From: Arnall, Guy <Guy.Arnall@newport.gov.uk>
Sent: 22 June 2026 12:50
To: Davidson, Joanne (East Area Development Manager)
<Joanne.Davidson@newport.gov.uk>
Subject: RE: Planning Consultation Request for case ref: 26/0367

Re: S73 APPLICATION TO VARY CONDITIONS 1 (APPROVED PLANS), 8 (SPRINKLER TANK DETAILS), 9 (LANDSCAPING), 15 (LIGHTING) AND 16 (BOUNDARY DETAILS) OF 25/1030 CONSTRUCTION OF A NEW SPORTS AND TEACHING FACILITY INCLUDING ALTERED PARKING ARRANGEMENTS AND ASSOCIATED LANDSCAPING AND INFRASTRUCTURE. AMENDMENTS INCLUDE RELOCATION OF SPRINKLER AND HYDRANT TANKS

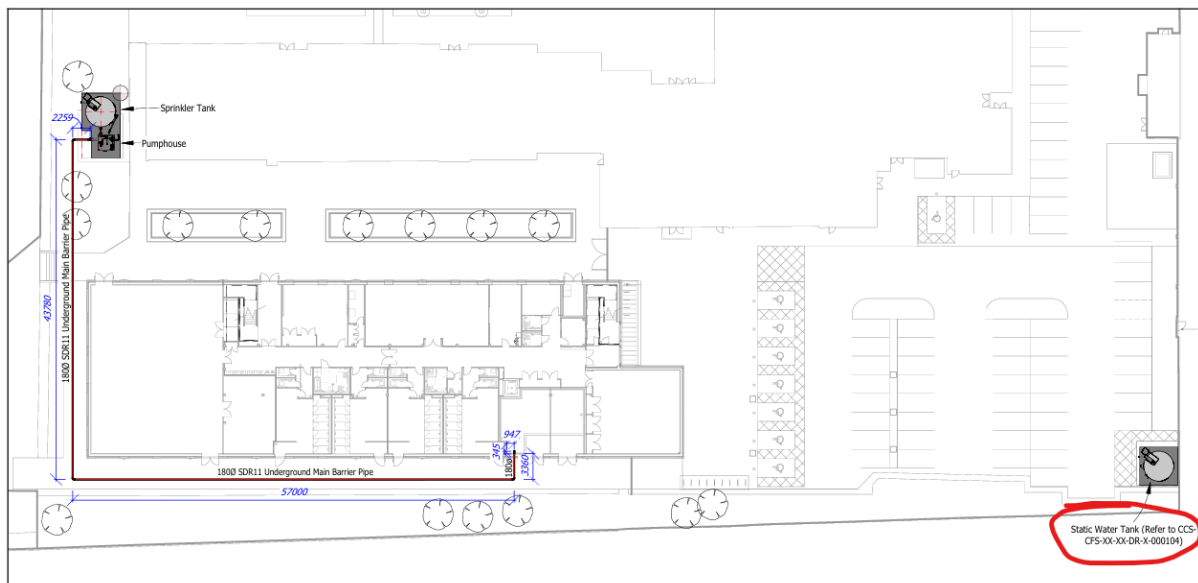
Whilst PV panels would be unobtrusive on the roof due to the significant parapet upstand to its perimeter (and formed part of the previous approval - see Drawing no. CCS-HLM-NN-R1-DR-A-00131 Rev.P03 submitted under 25/1030), ASHPs are more likely to have a visual impact. A section through the building has now been provided, to show height of the proposed in relation to parapet upstand of roof. Though the proposed rooftop plant projects slightly higher than the parapet, it seems that their visibility will be very low, due to their proposed location on the roof (set away from the parapet edge).
